Subject: A/YL-PH/1090

回應部門提問

A/YL-PH/1090
交通流量評估

圖1

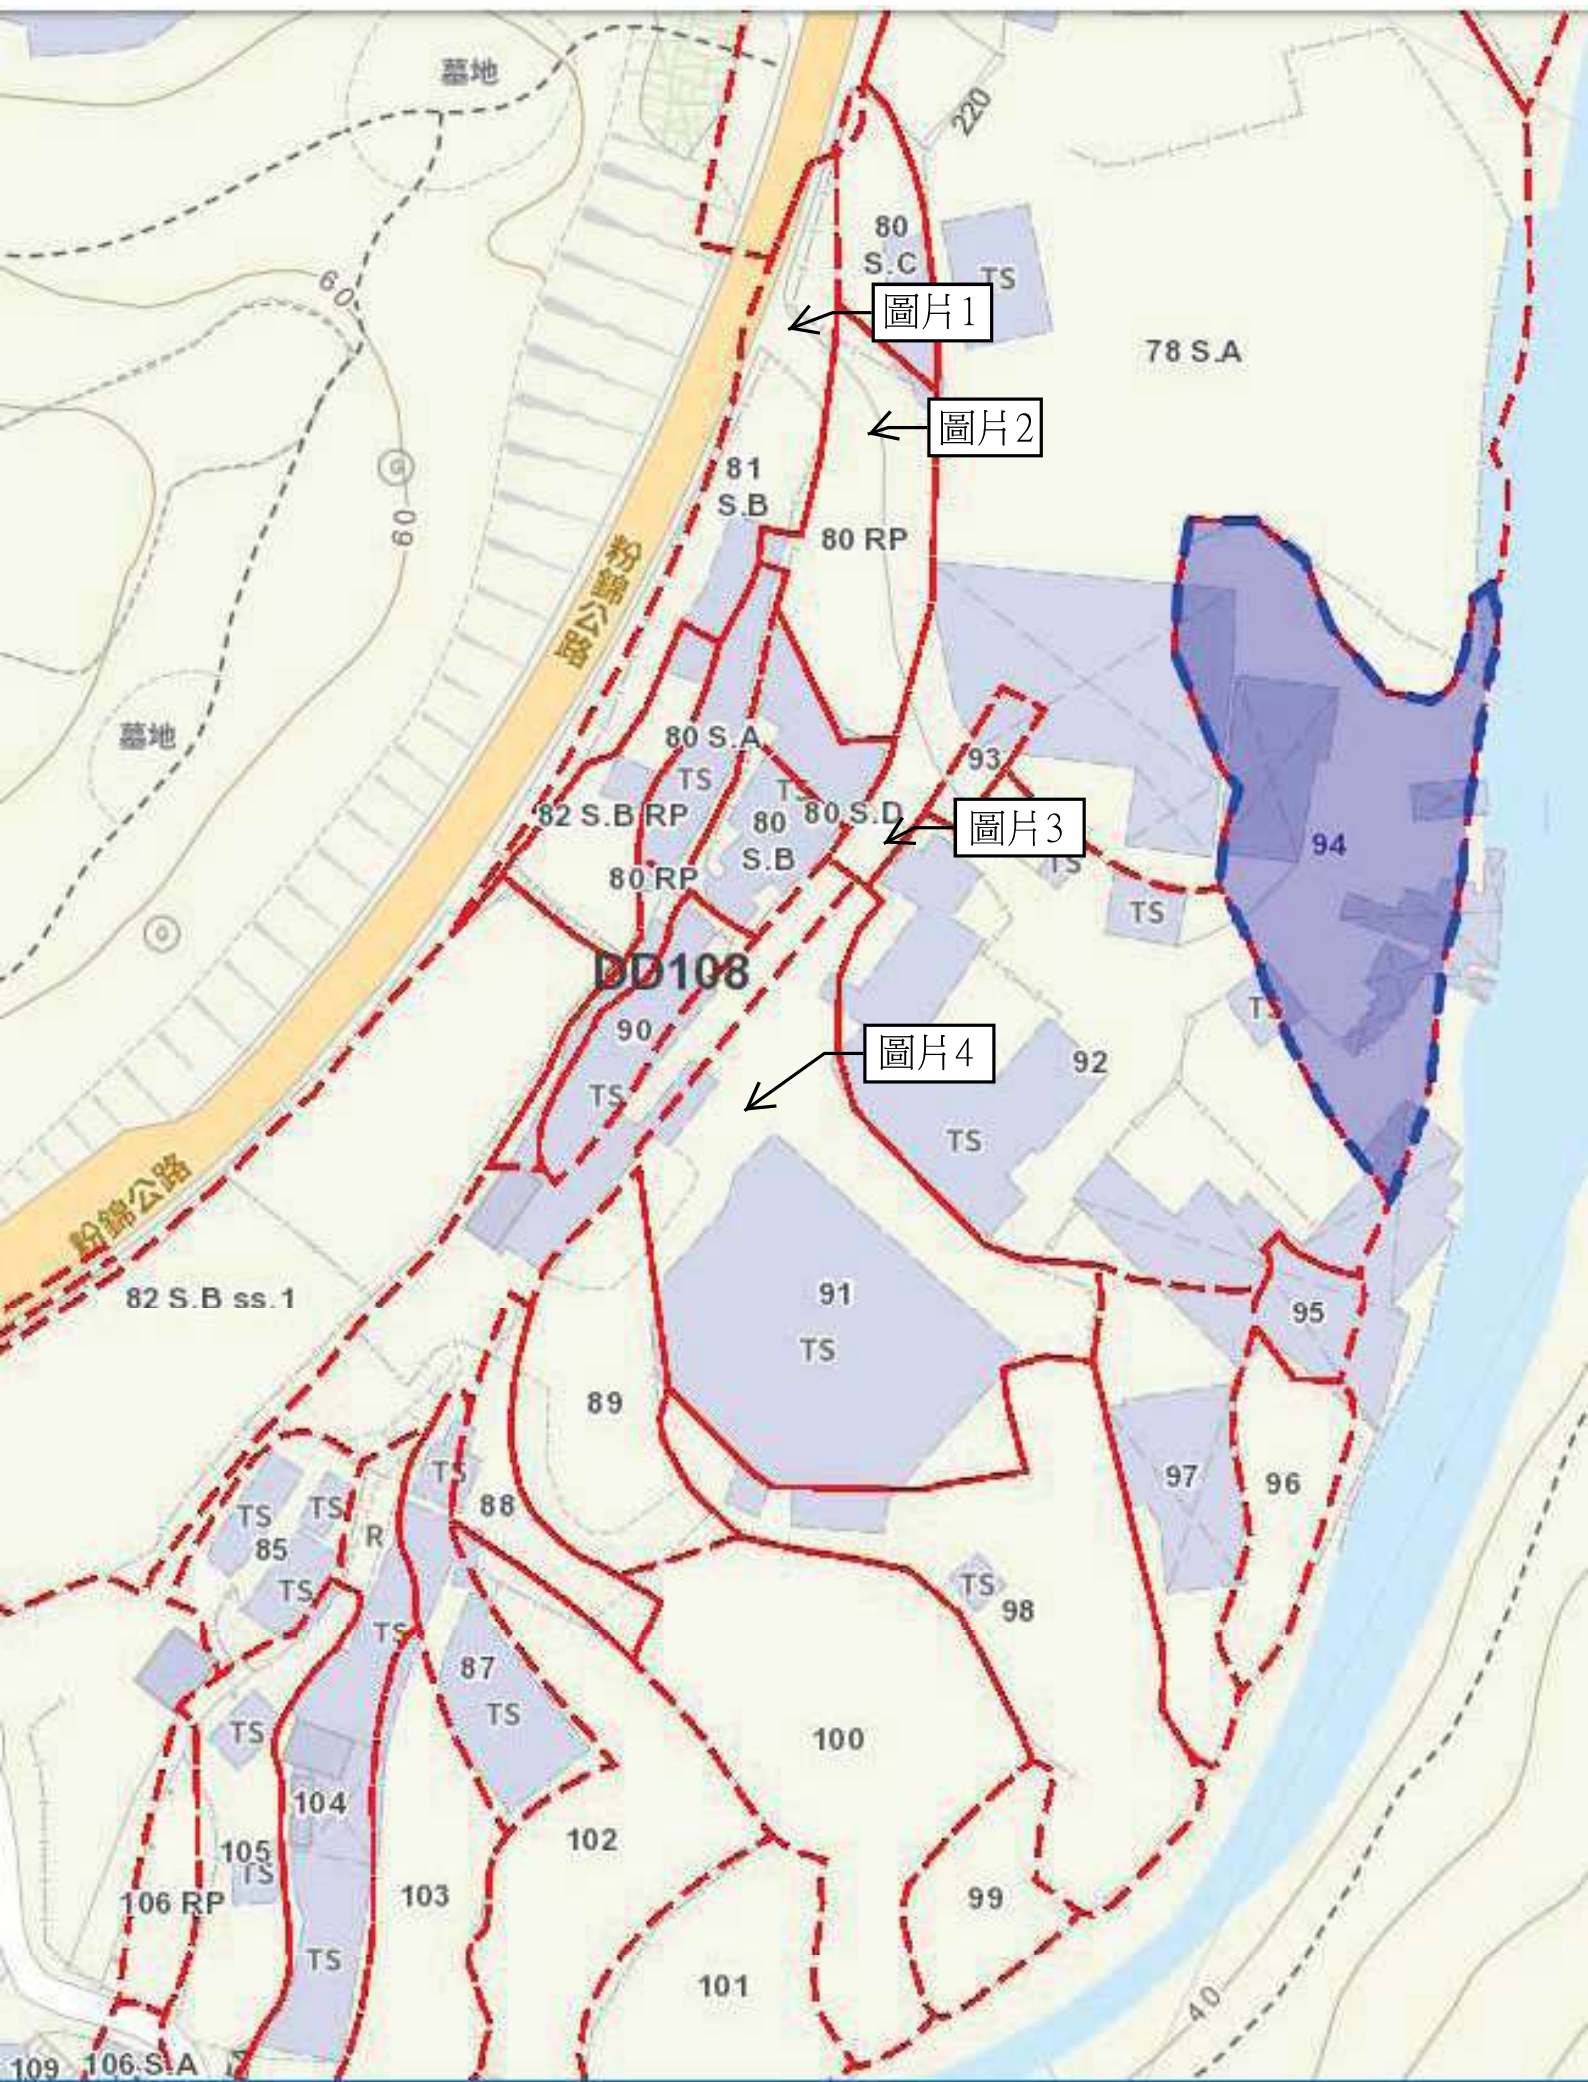
路口闊8米

此段路闊6.7米

此段路闊6米

此段路闊5米

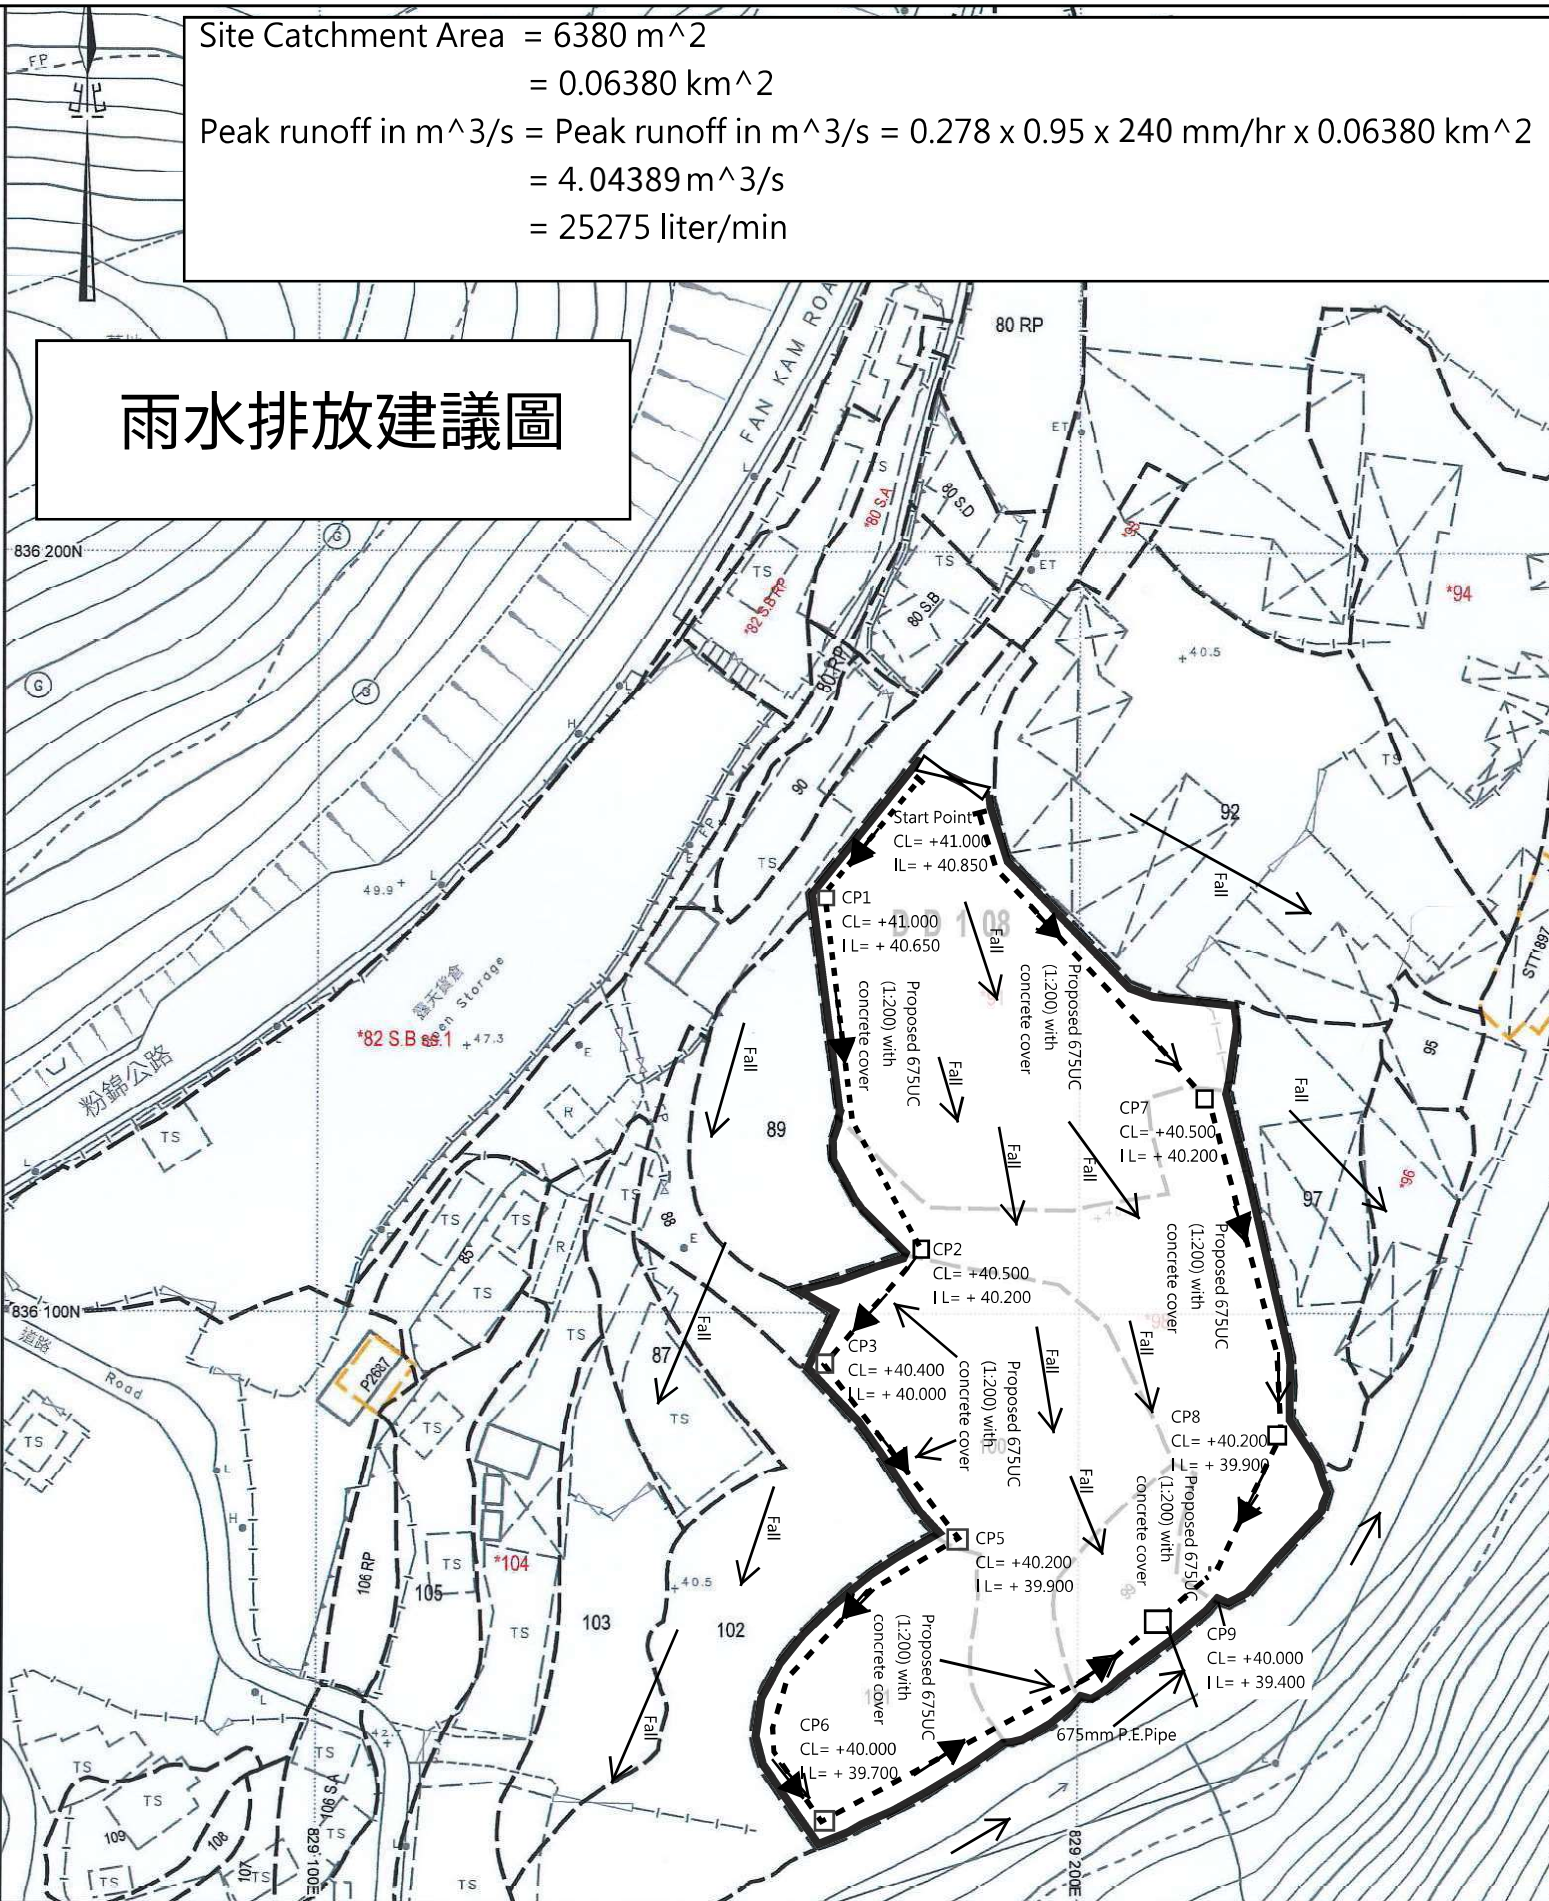
(g) Please show the connection details at discharge point and indicate all C.L., I.L and catchpit/watercourse B.L. in the drawing.

(h) Calculation to demonstrate the downstream drainage system receiving the discharge from the development has adequate spare capacity to accommodate the runoff is required.

(i) Please provide channel to the entrance to accrue runoff from the application site and to intercept the overland flow from the adjacent lands.

- (l) Cross sections showing the existing and proposed ground levels of the captioned site with respect to the adjacent areas should be given.

- (m) The applicant shall resolve any conflict/disagreement with relevant lot owner(s) and seek LandsD's permission for laying new drains/channels and/or modifying/upgrading existing ones in other private lots of on Government land outside the application site.

已在新設計圖內列明。

已在新設計圖內列明有關細則

已在新設計圖內列明

已在新設計圖內列明

我等不須要經過其他私人土地，可直至經政府土地流向河道。
